LR-N07-0112

Salem Nuclear Generating Station, Units 1 and 2
Facility Operating License Nos. DPR-70 and 75
NRC Docket Nos. 50-272 and 50-311

Hope Creek Generating Station
Facility Operating License No. NPF-57
NRC Docket No. 50-354

Subject: Request For Emergency Plan Change

Timeline Depiction of ERO Augmentation

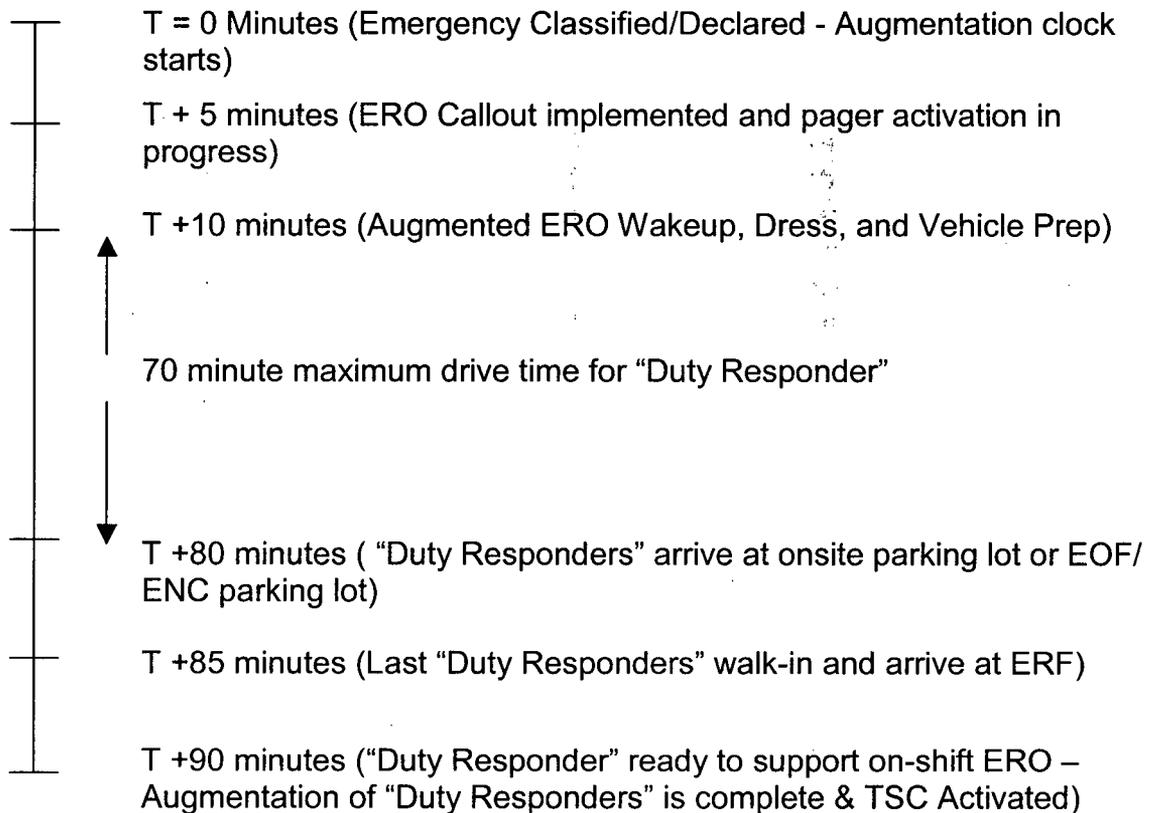
Implementing the proposed change such that a “duty responder” position can respond within 90 minutes to their assigned ERF will increase the pool of Salem and Hope Creek personnel available to fill ERO “Duty Positions.” The data shown in Table 1 indicates that increasing the drive time requirements for ERO “Duty Responders” from the current 60 minutes to 70 minutes will increase the percent of employees available to fill ERO “Duty Responder” positions at onsite ERFs from 73.3% to 90% or an additional 112 employees and will increase the percent of employees available to fill ERO “Duty Responder” positions at the Emergency Operations Facility (EOF) or Emergency News Center (ENC) from 89.7% to 96.3% or an additional 45 employees. This increased pool results in 96.3% of PSEG Nuclear employees that will be eligible to fill an ERO “Duty Responder” position at the Salem and Hope Creek Generating Stations. The below timeline is presented to illustrate the proposed ERO Augmentation components.

PSEG NUCLEAR LLC
ON SHIFT STAFFING
EMERGENCY
RESPONSE
ORGANIZATION
(FIGURE 3-1)

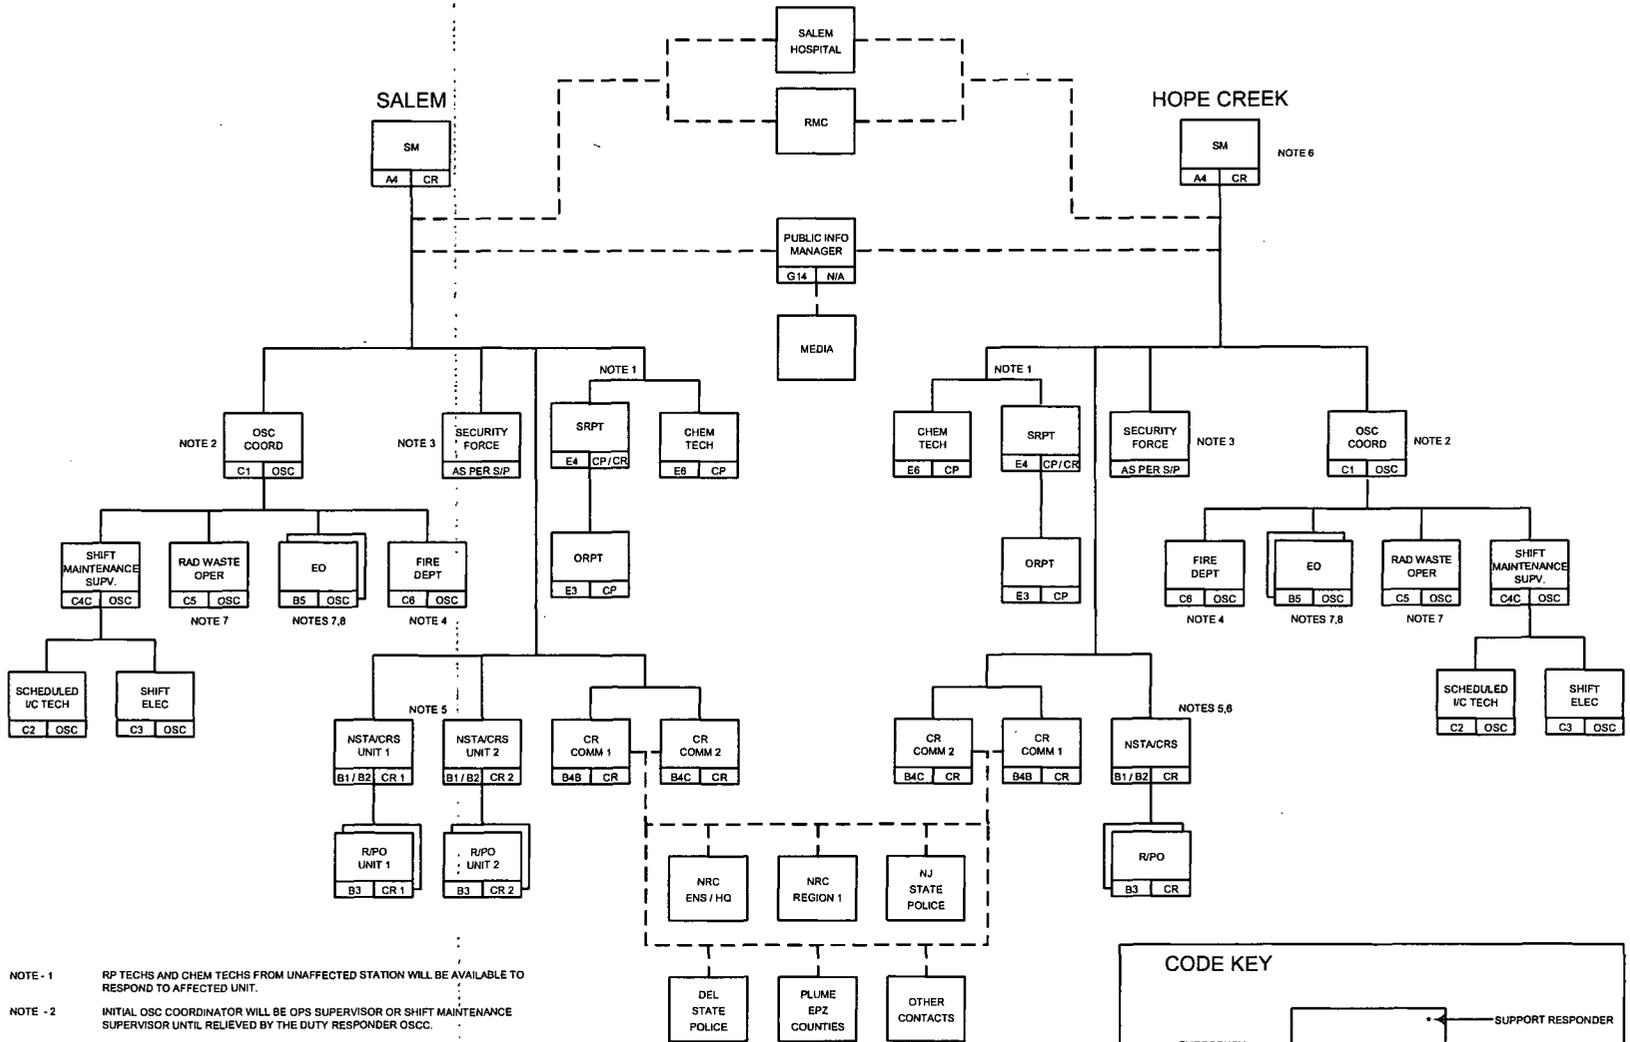
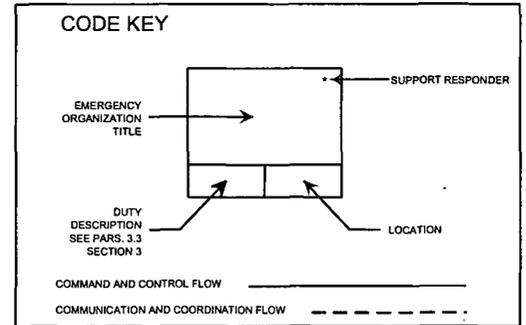
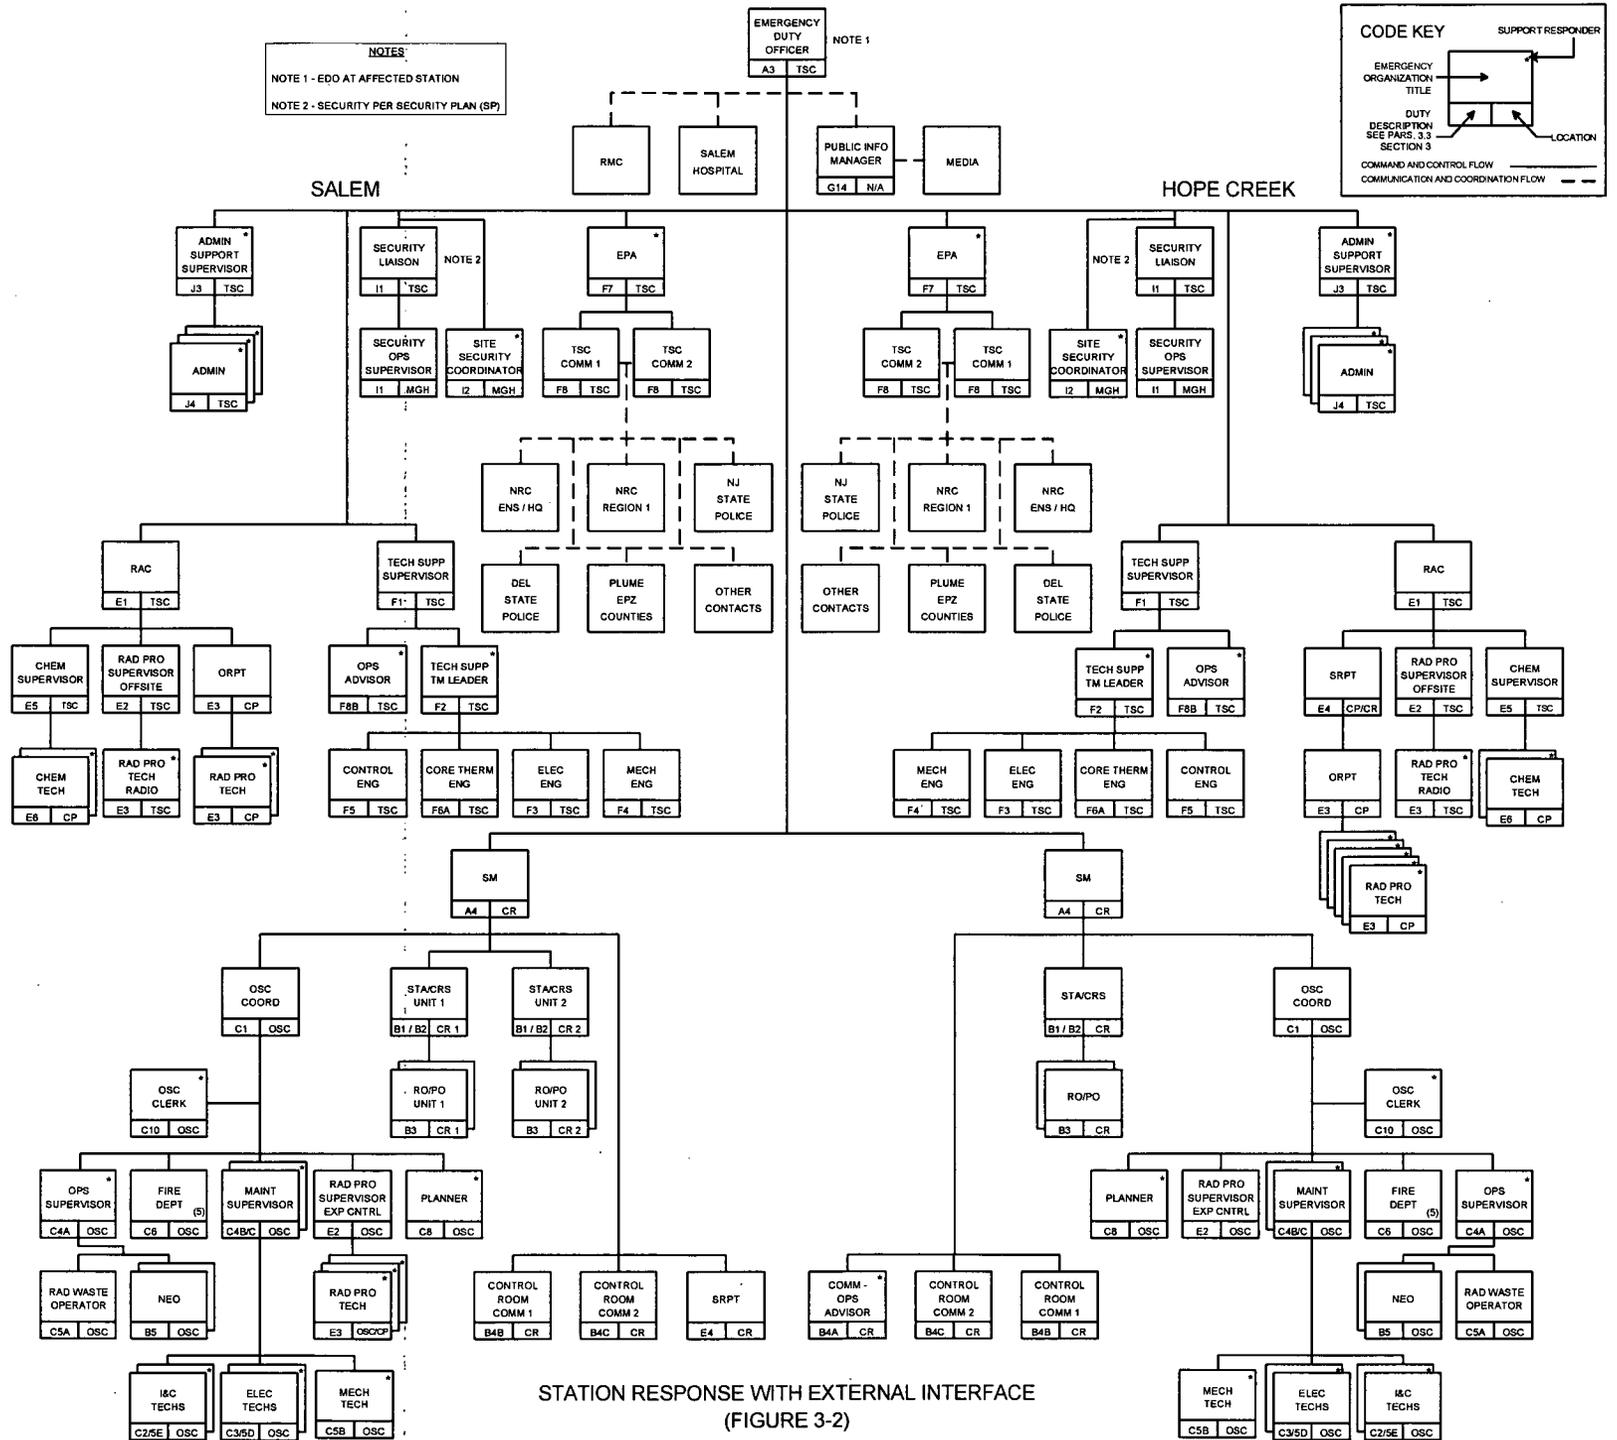
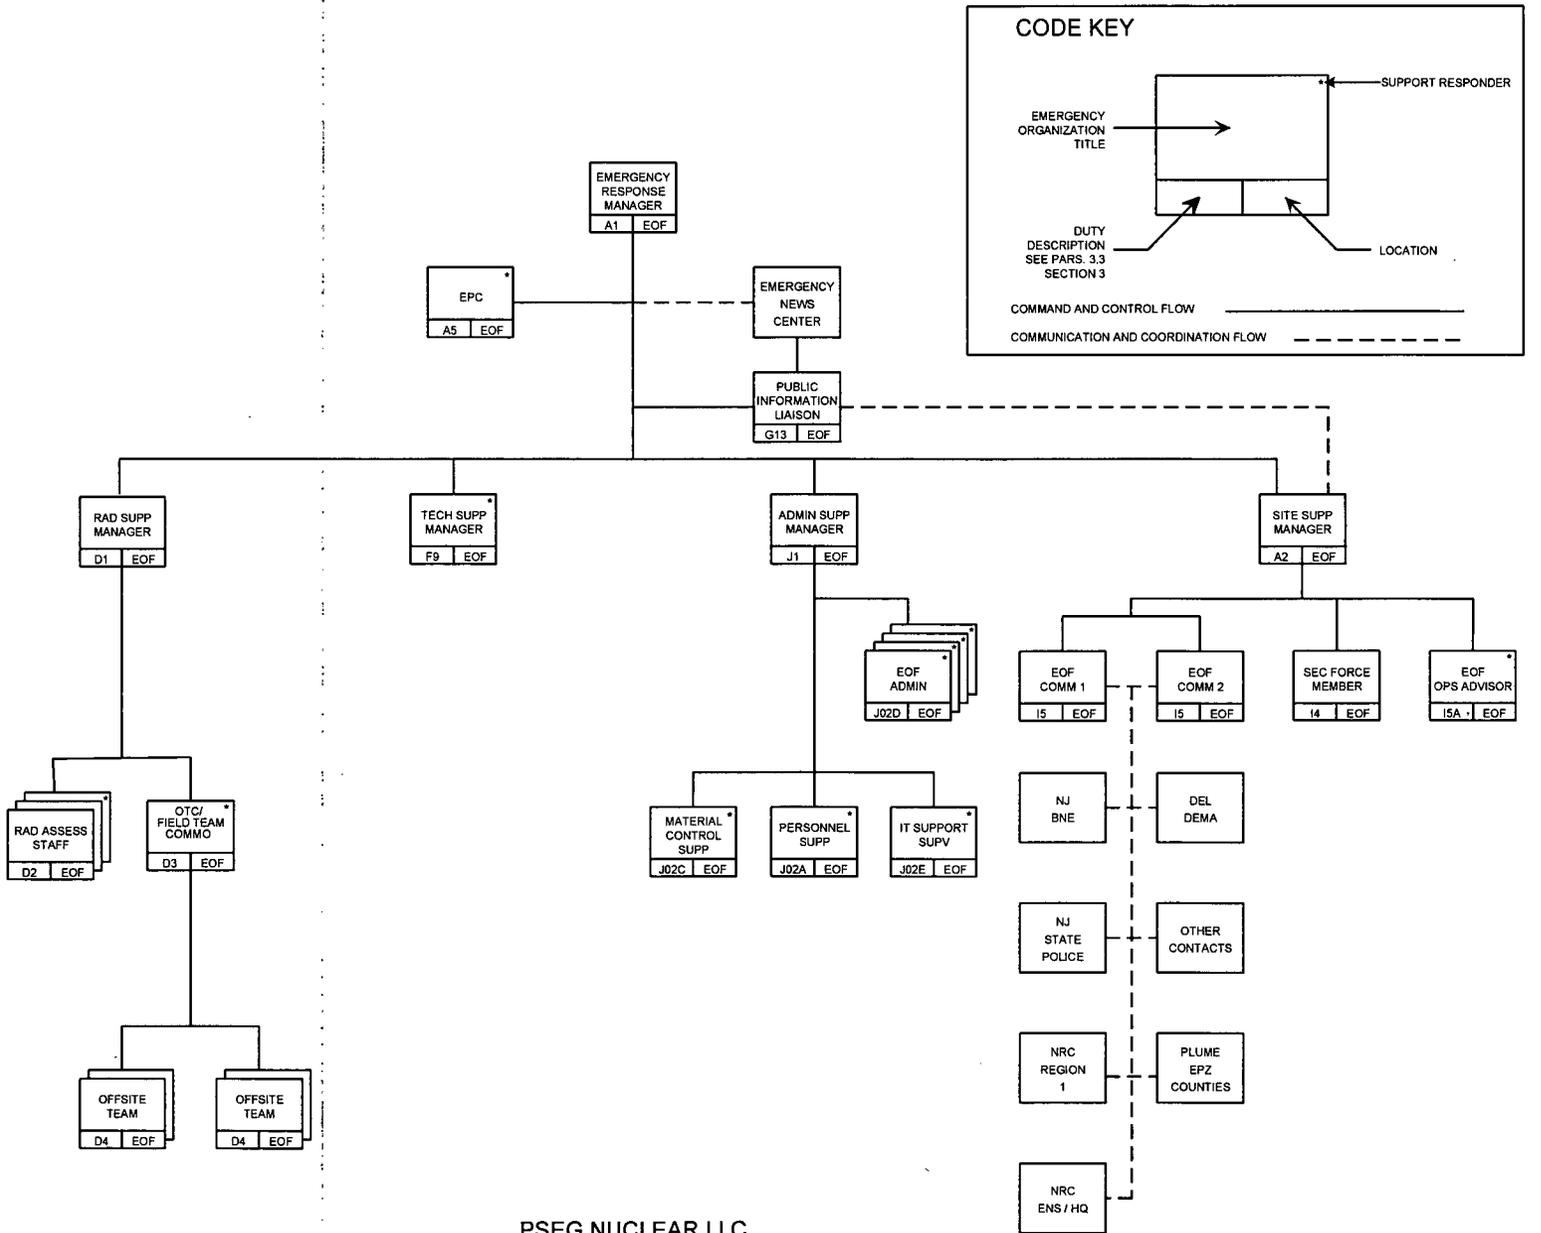
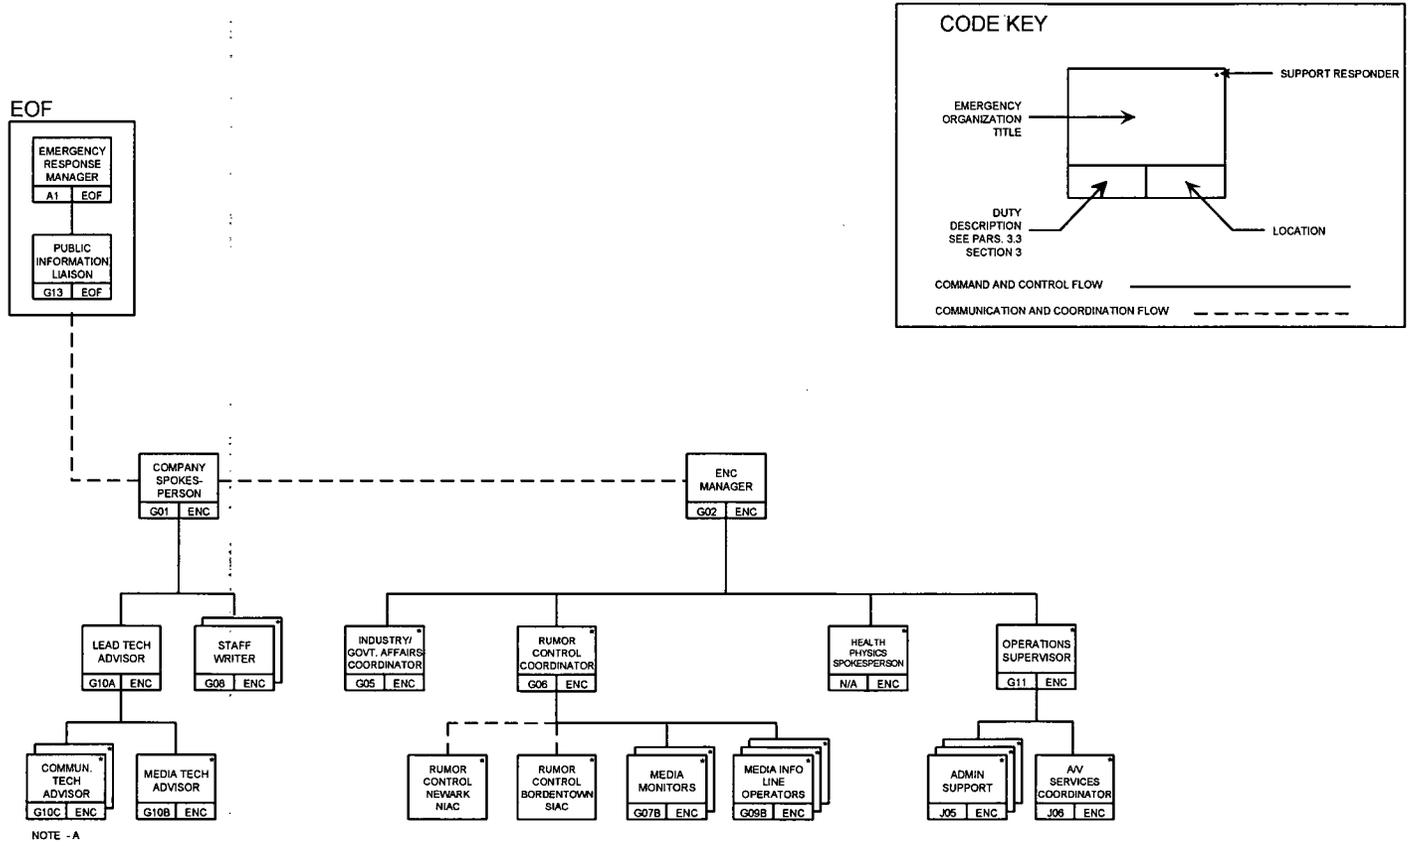
2. Revision to the E-Plan, Section 3, Section 9, and Figures 3-1, 3-2, 3-3, 3-4 to clearly indicate which positions are “support responder” positions. Positions not designated as support responder positions are either “on-shift” ERO positions or “duty responder” ERO positions.
